Access Compliance Report

Public Rights-of-Way

Intersection ID: 4923	Main Street: HEDGECREST_PL	Cross Street: MAYSPRING_PL	Location:	S
ADA ID: F35272BE3AA6	Ramp Type: Perp	Initial Pass/Fail: Fail	Overall Compliance: No	Severity Score: 25

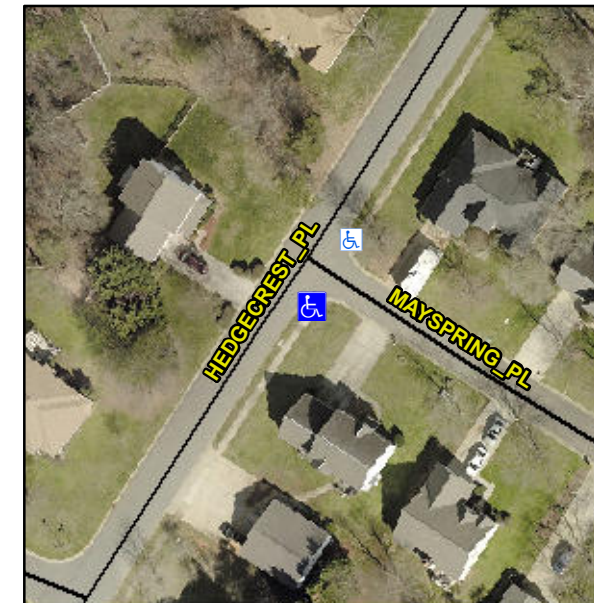
Not Found, R304.5.3

Compliance	Description	Data	Compliance	Description	Data
N/A	Ramp Length (in)	48.0	Yes	Ramp Slope (%)	7.2
Yes	Ramp Width (in)	48.0	No	Ramp XSlope (%)	10.0
N/A	Flare Type LT	N/A	N/A	Flare Type RT	N/A
N/A	Flare Slope LT (%)	N/A	N/A	Flare Slope RT (%)	N/A
N/A	Flare Traversable LT?	N/A	N/A	Flare Traversable RT?	N/A
N/A	Landing Length (in)	N/A	N/A	DWS Provided?	N/A
N/A	Landing Width (in)	N/A	N/A	DWS Contrast?	N/A
N/A	Landing Slope (%)	N/A	N/A	DWS Length (in)	N/A
N/A	Landing X Slope (%)	N/A	N/A	DWS Full Width?	N/A
N/A	Landing Curb? (Y/N)	N/A	N/A	DWS Offset (in)	N/A
N/A	Shared Landing?	N/A			
N/A	Gutter Ponding?	N/A	N/A	Gutter Slope (%)	N/A
N/A	Gutter Lip Ht (in)	N/A	N/A	Gutter X Slope (%)	N/A
N/A	Painted X Walk1?	No	N/A	Painted X Walk2?	N/A
	X Walk 1 Direction	To NE		X Walk 2 Direction	N/A
N/A	X Walk 1 Width (in)	N/A	N/A	X Walk 2 Width (in)	N/A
	X Walk 1 Slope (%)	0.8		X Walk 2 Slope (%)	N/A
	X Walk 1 X Slope (%)	8.4		X Walk 2 X Slope (%)	N/A

Remove & Replace Entire Ramp.
